**Meridian Airport Authority, Dean Aircraft Services
Hangar Additions & Alterations**

ADDENDUM NO. 4

TO: All Bidders on the Above Referenced Product
FROM: Davis Purdy Architects, PLLC
DATE: March 17, 2020
SUBJECT: **ADDENDUM NO. 4**

E-205

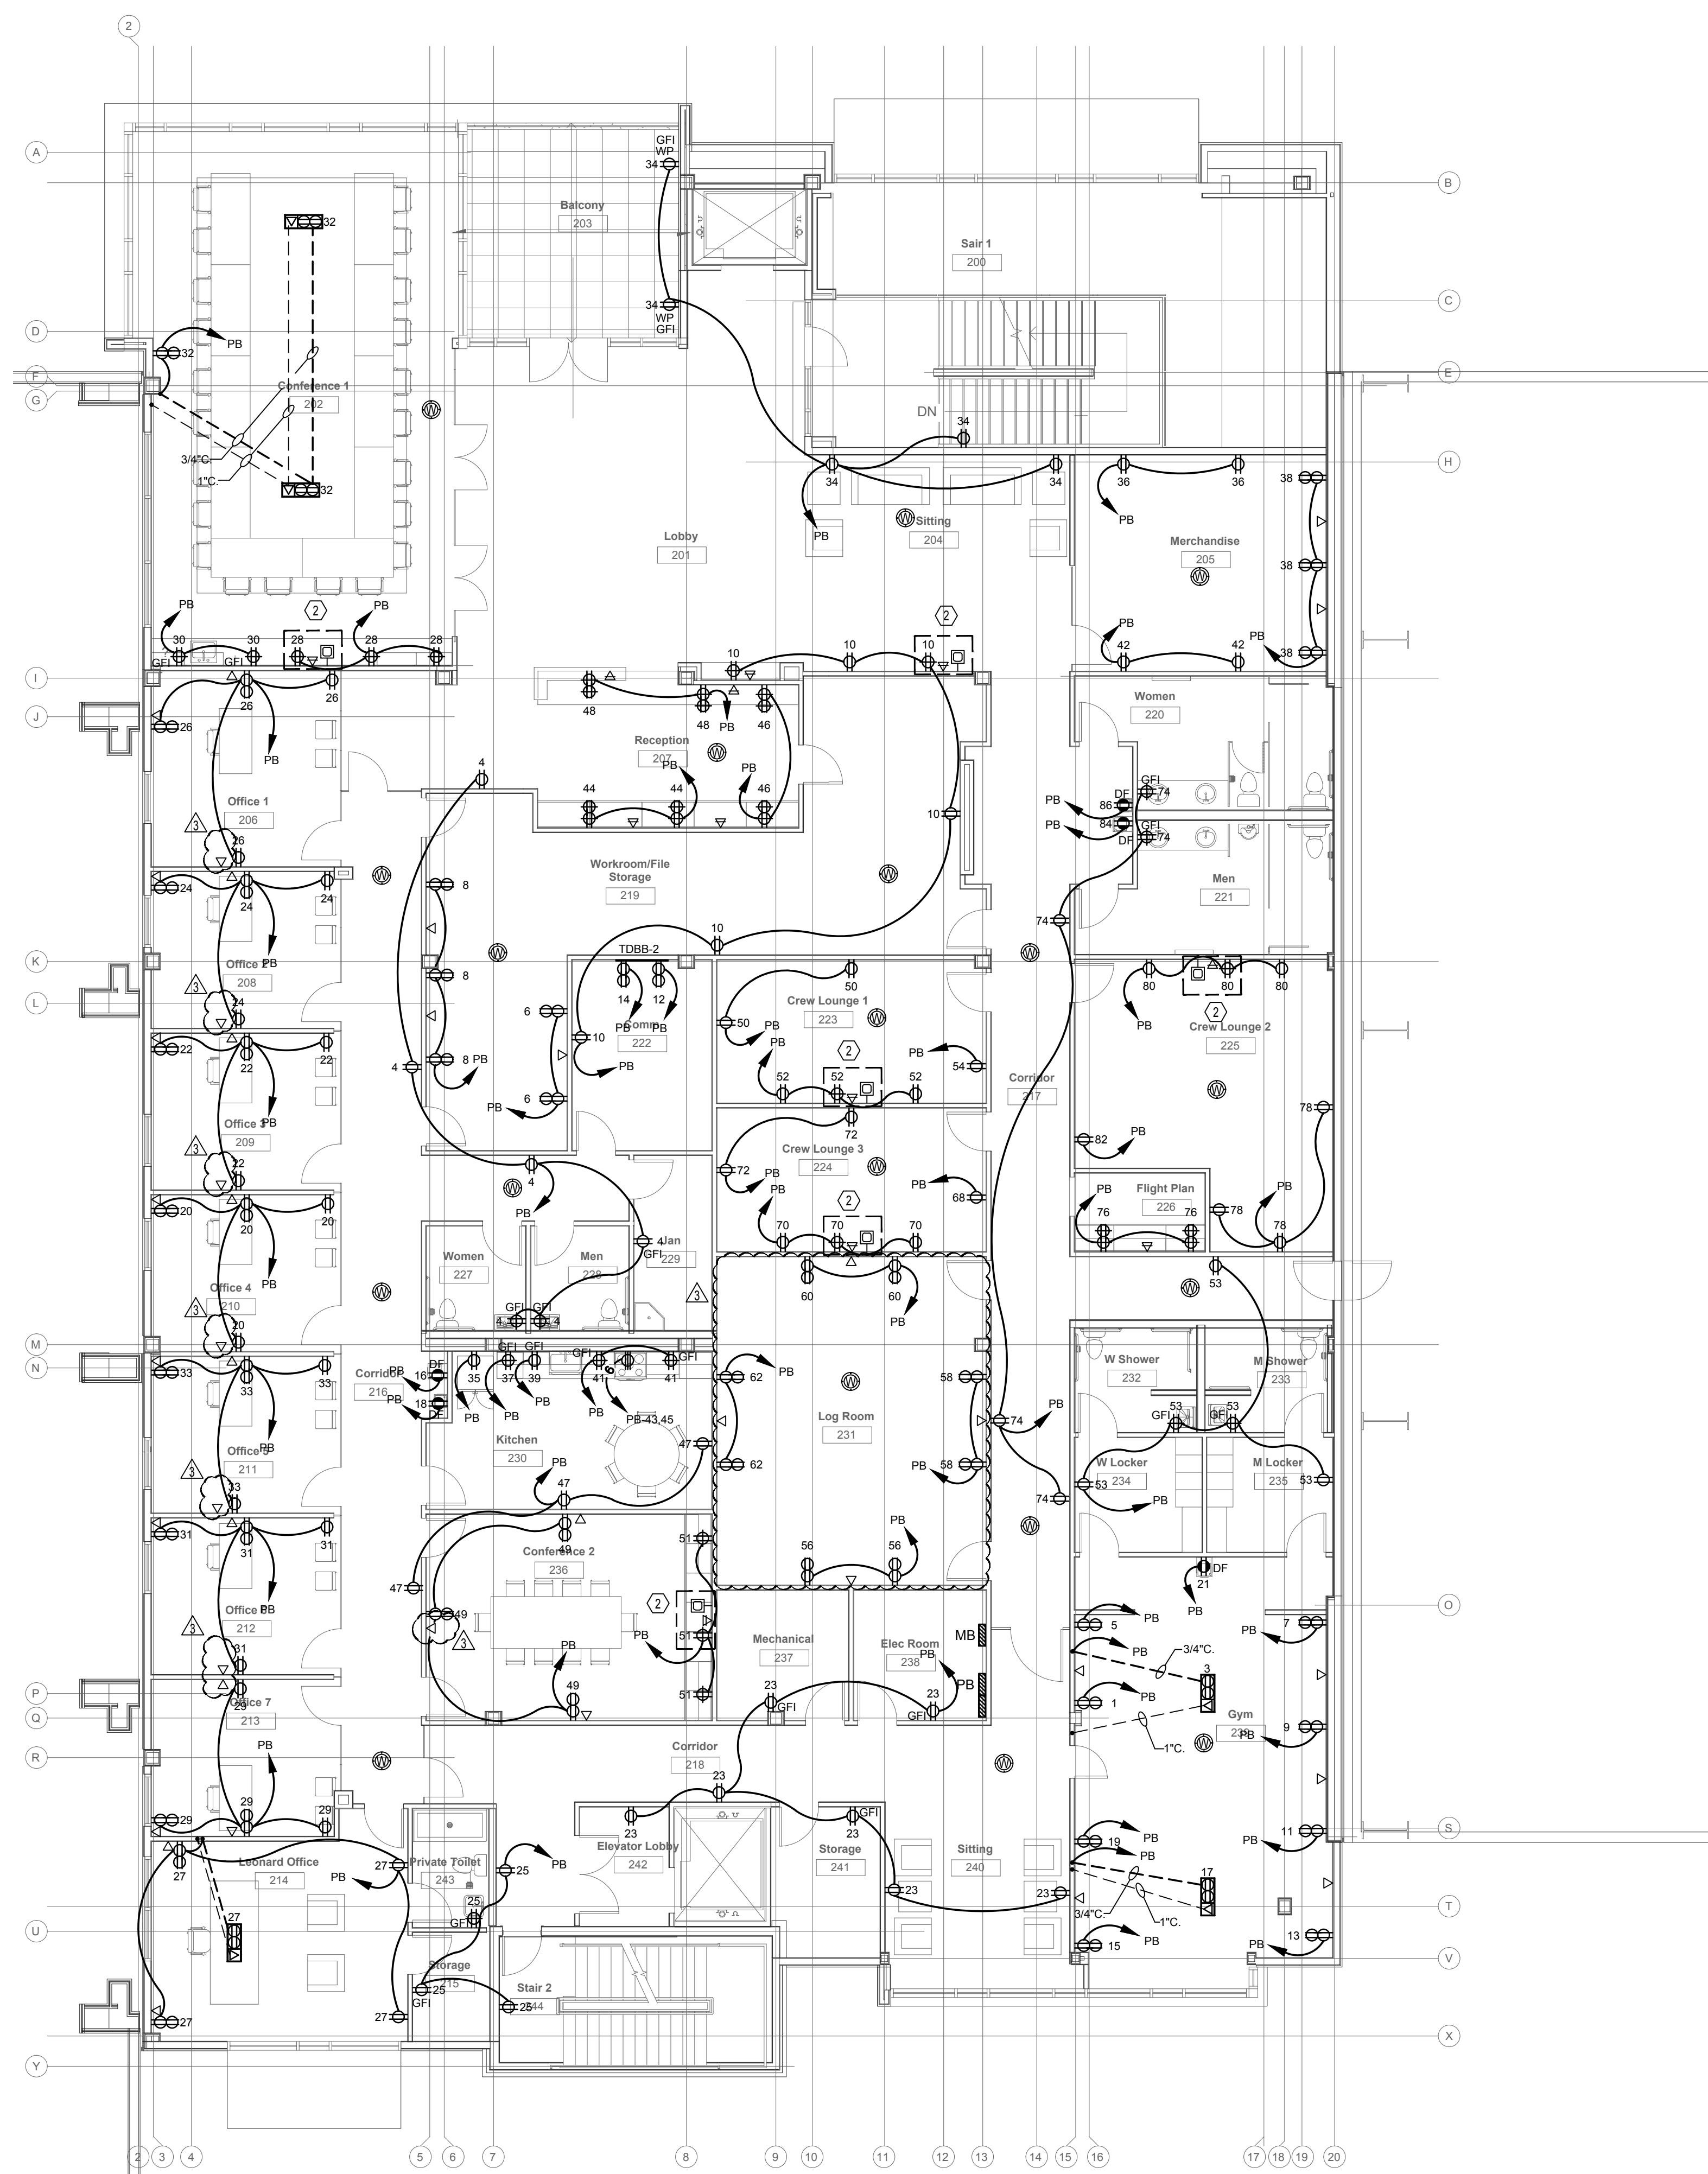
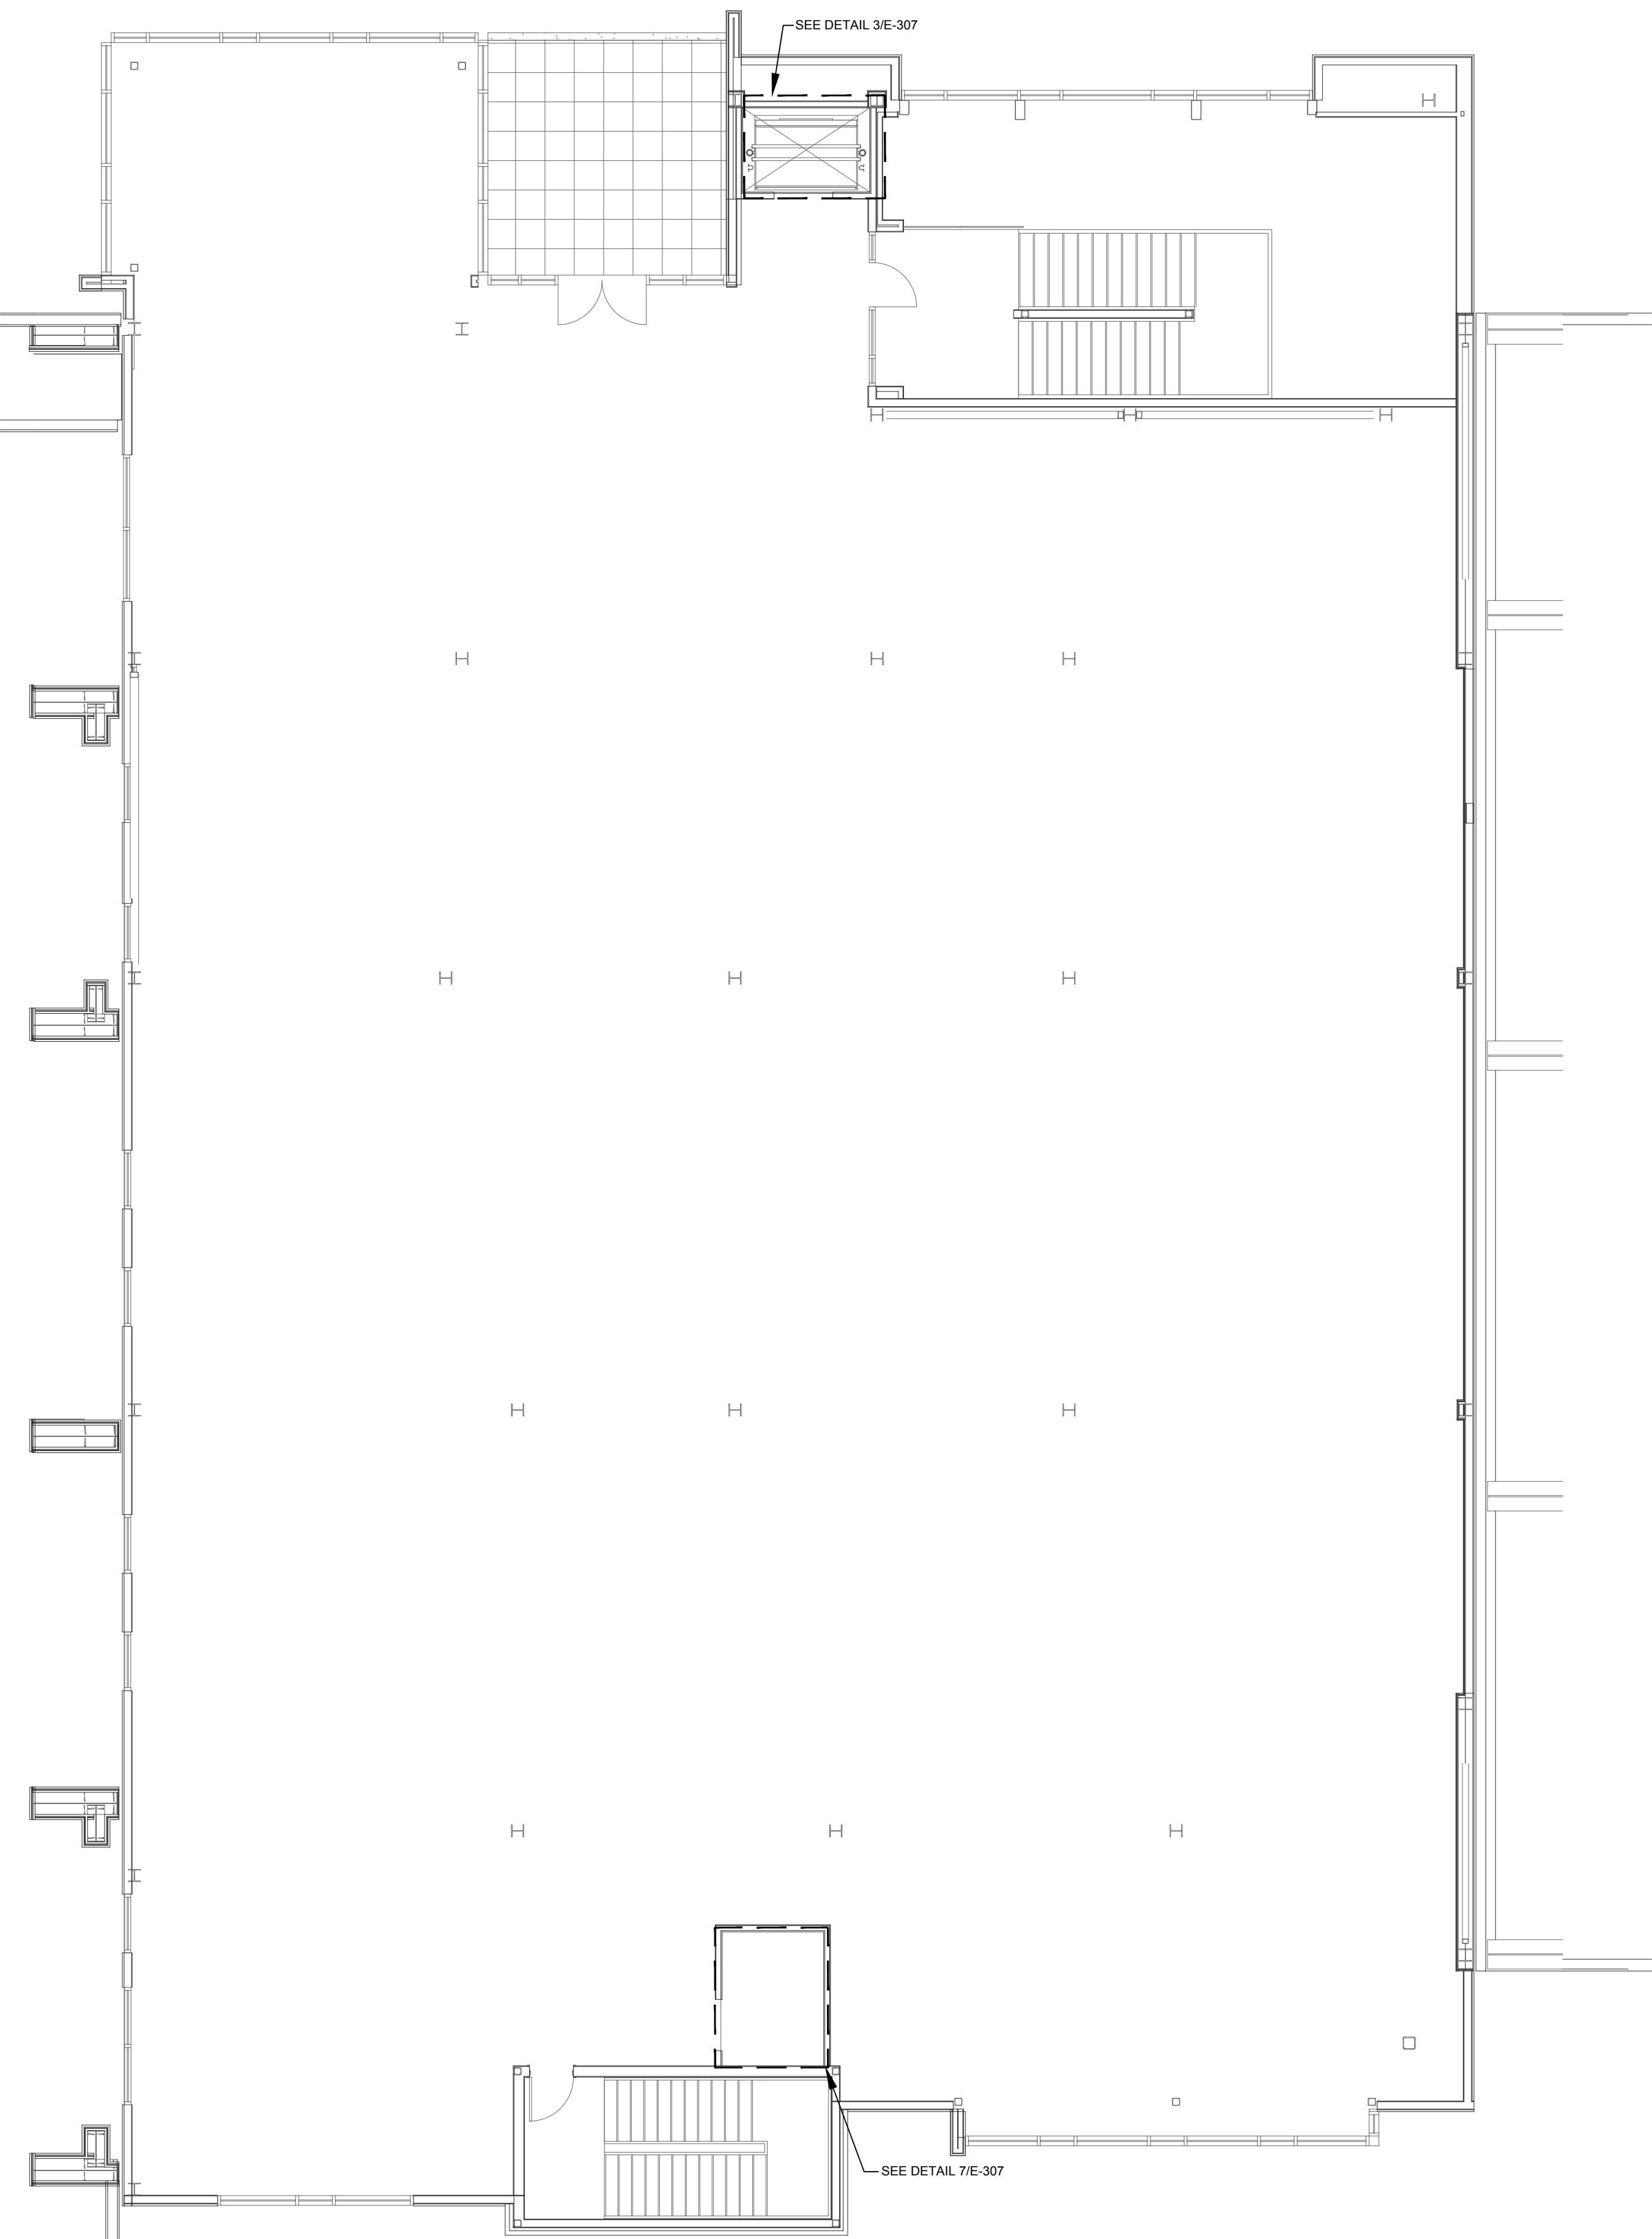
- i. Added Data Devices.
 - j. E-205 PARTIAL POWER PLAN 2ND & 3RD – FLOOR PART D & E**
 - i. Added Data Devices.
 - ii. Modified Power and Data layout in Log Room 231.

Sheet Title
PARTIAL AUXILIARY PLAN 1ST FLOOR PART A

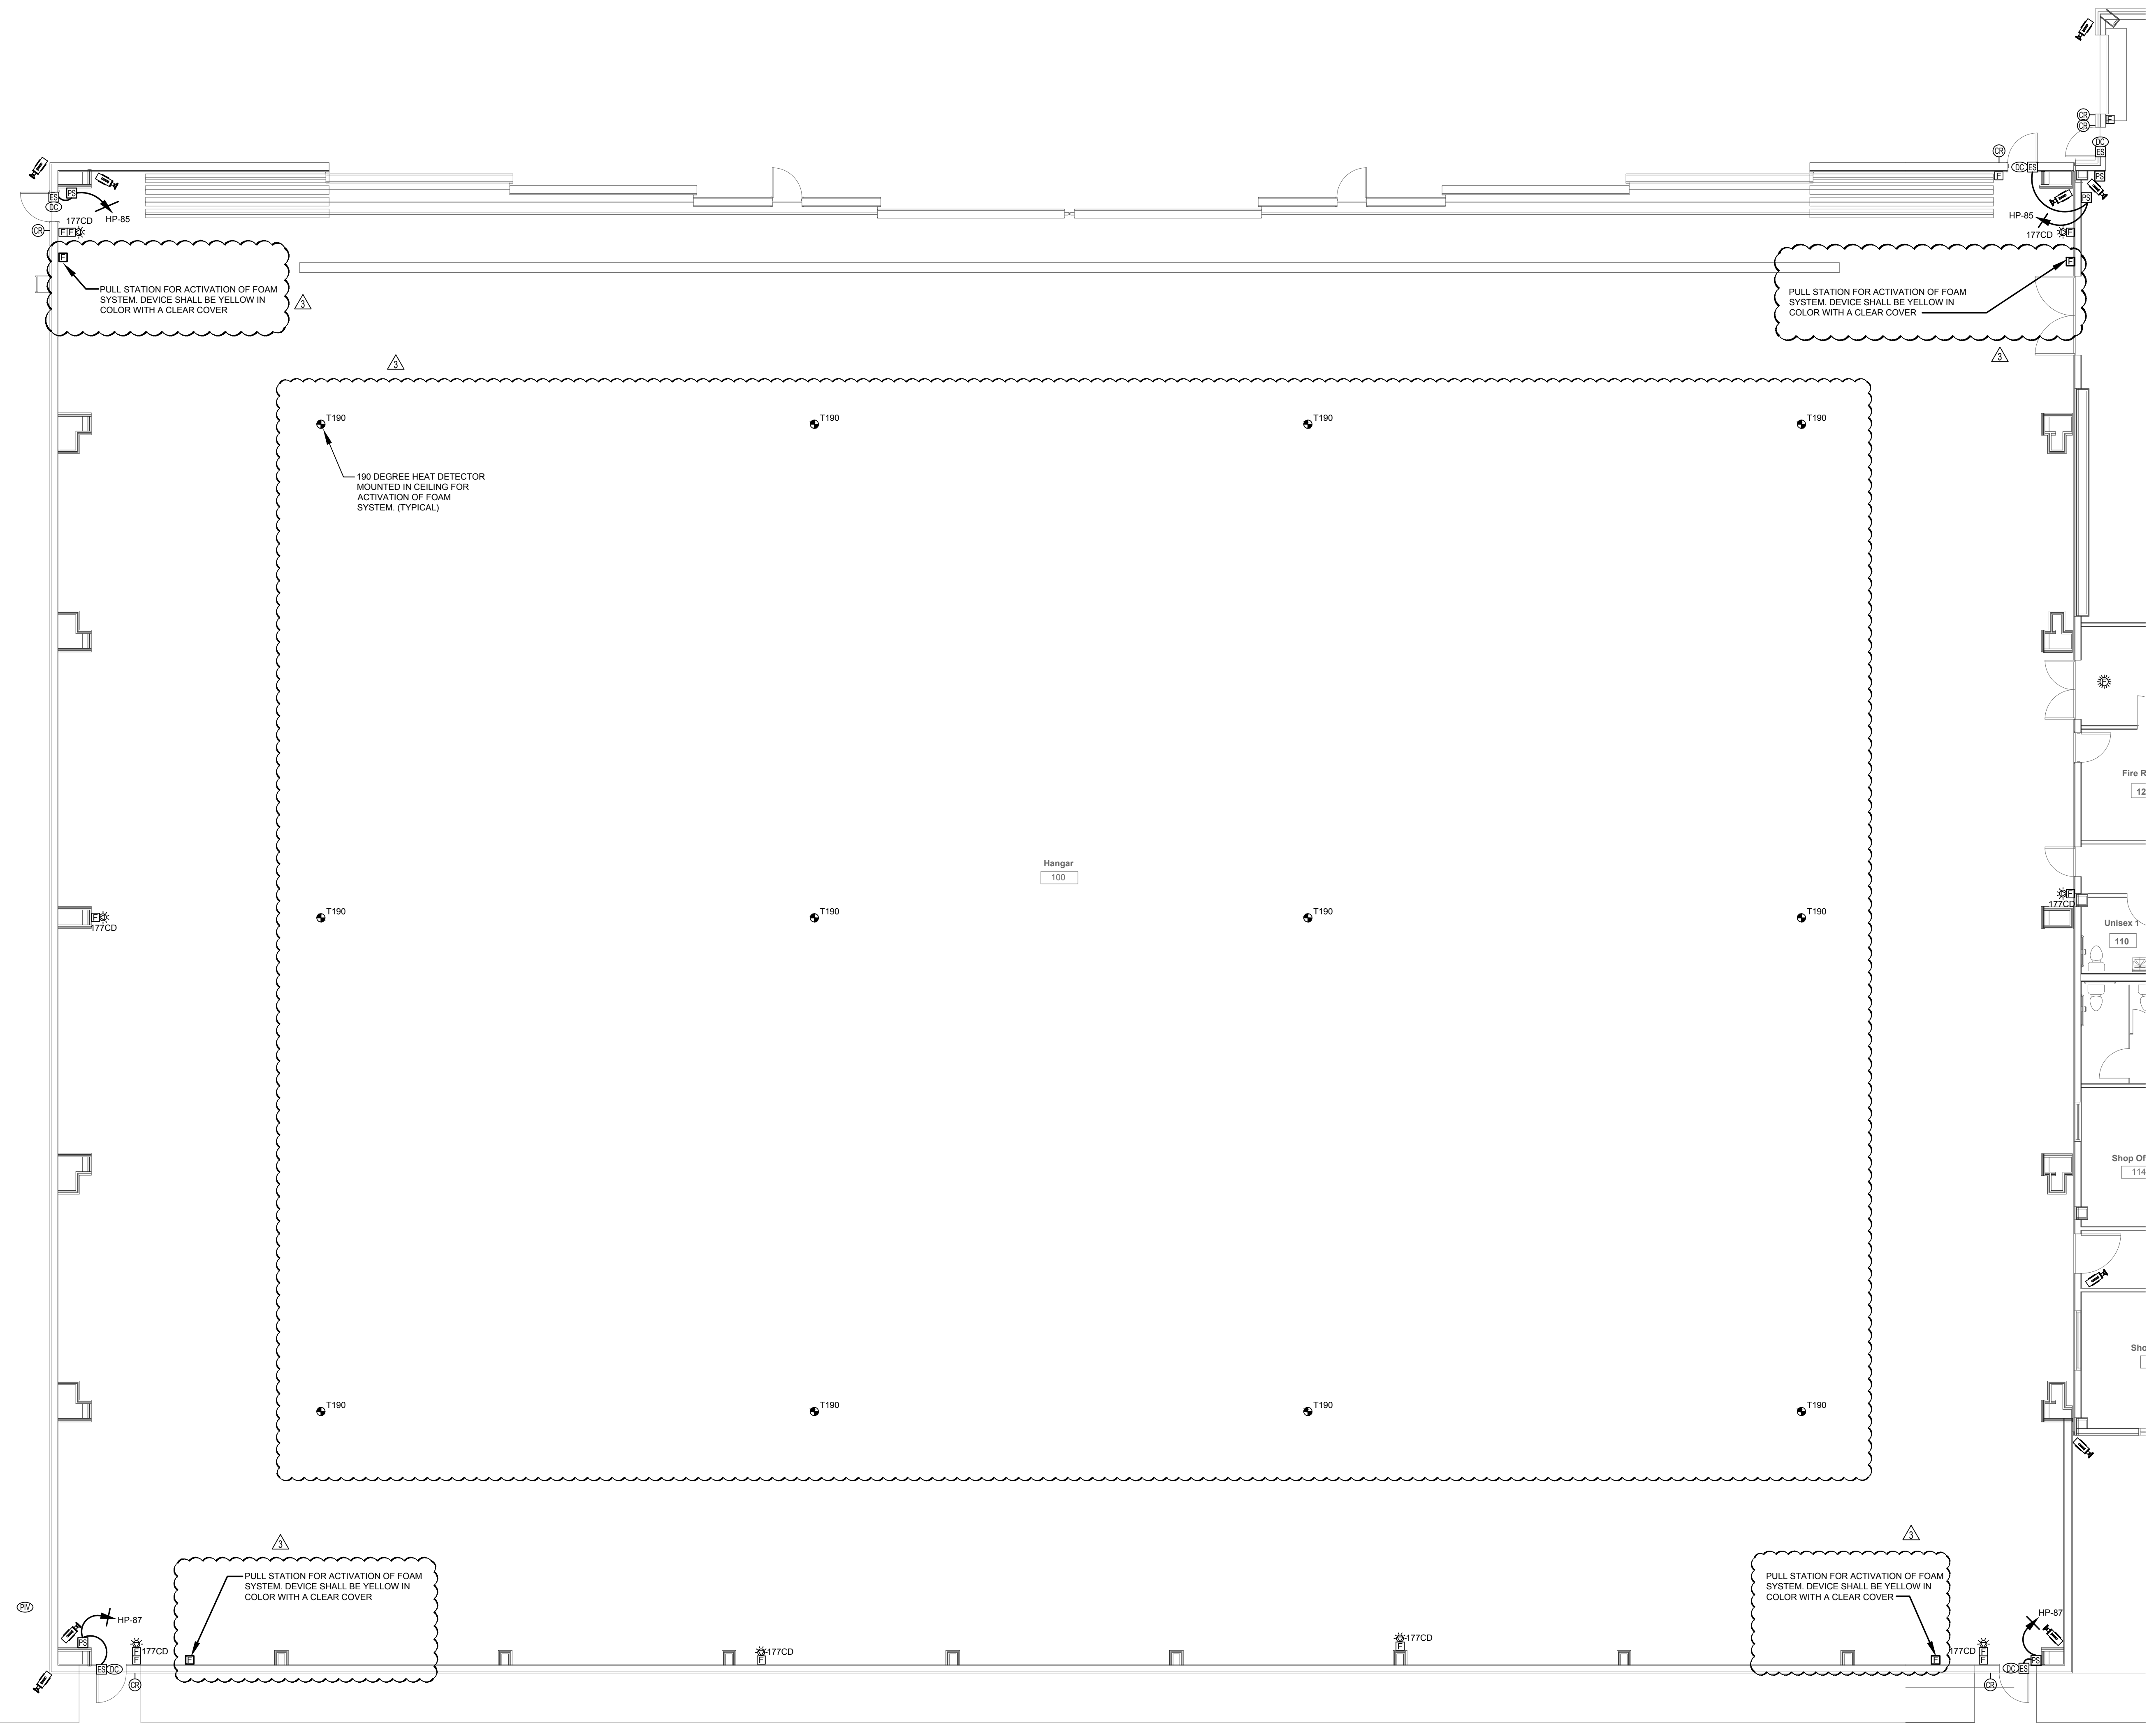
- k. E-301 PARTIAL AUXILIARY PLAN 1ST FLOOR PART A**
 - i. Added Fire Alarm Devices and notes describing the devices.
 - l. E-500 ELECTRICAL PANEL SCHEDULES**
